Amendments to the Drawings

REMARKS/ARGUMENTS**1. Drawings**

FIG. 4

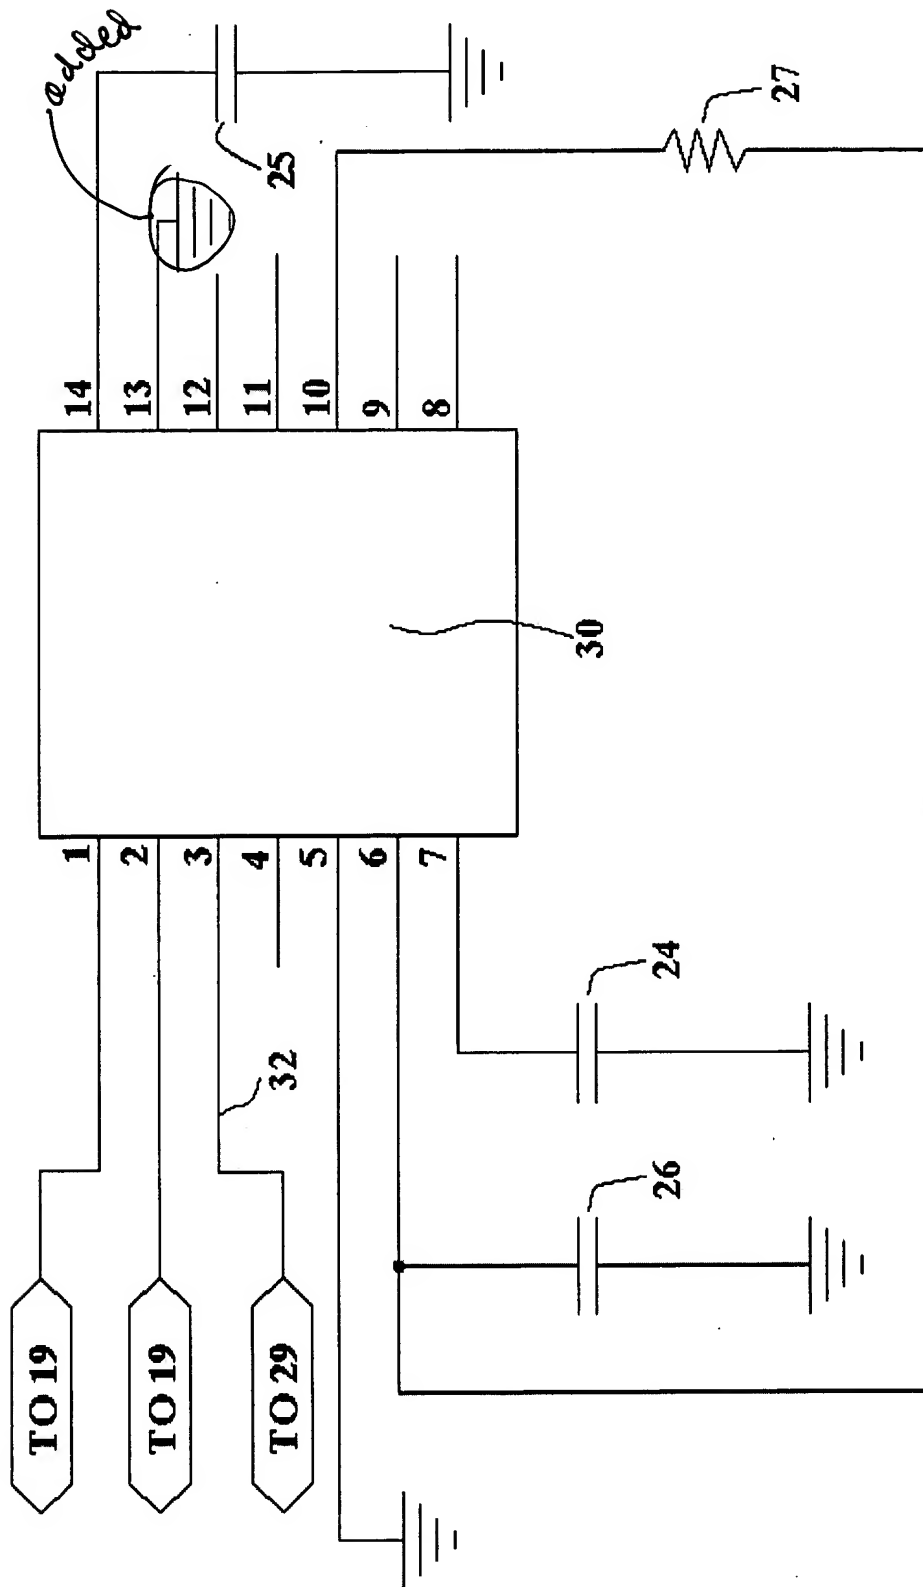
The attached drawing sheet includes a change to Fig. 4. The sheet includes only Fig. 4, the original of which it replaces. Per the objection made in the Office Action, this figure has been revised to include a depiction of the grounding of pin 13.

As noted above, Fig. 4 has been revised to include a depiction of the grounding of pin 13, per the objection made in the Office Action.
